The ARAMARK Tower
1101 Market Street
Philadelphia, Pennsylvania 19107-2994

On behalf of the Philadelphia Water Department (PWD), I wanted to thank you and your colleagues at the PADEP for taking the time to meet with us on June 14 to discuss your comments submitted June 6, 2012 on our Implementation and Adaptive Management Plan (IAMP) submittal.

David Burke's Comments

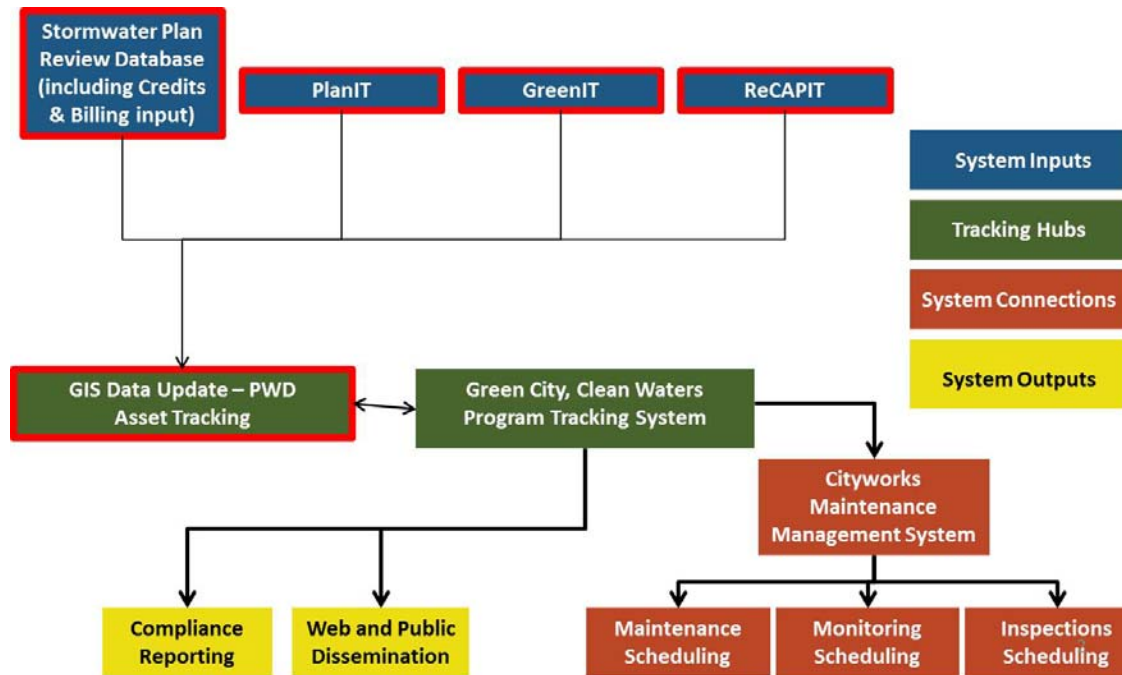
1. Section 2.1.1 (“Tracking System Development”) contains a brief discussion of the Interim Tracking System and the Green City Clean Waters Program Tracking System (“GCCW System”). DEP requests that the City provide a more detailed schedule for the completion and implementation of the GCCW System. The language in this section implies that the system may not be completed until the fifth year of the program, and this implied time frame gives DEP some concern. We request Philadelphia Water Department’s (“PWD”) explanation of why this task is extended over such a long time, as well as a discussion of how PWD intends to handle the transition from using the Interim Tracking System to using the GCCW System.

As described in the IAMP, the Water Department already has a number of robust data tracking systems in place and being utilized. What is planned is the integration of these existing data tracking systems through the creation of a *Green City, Clean Waters* Program Tracking System “hub” as a means of simplifying the compilation of information from these various systems for improved information dissemination and regulatory reporting. On page 2-2 of the IAMP, the following figure illustrated PWD’s vision for linking project tracking information.

In the months since the IAMP was submitted, PWD initiated updates to some of these systems to enhance their ability to track data and prepare for the development of the Green City, Clean Waters “hub”. This has resulted in an evolved graphical representation of PWD’s vision for the master

tracking system. Highlighted with a red outline in the graphic below are sub-elements to the tracking process that have seen significant progress in the past few months.
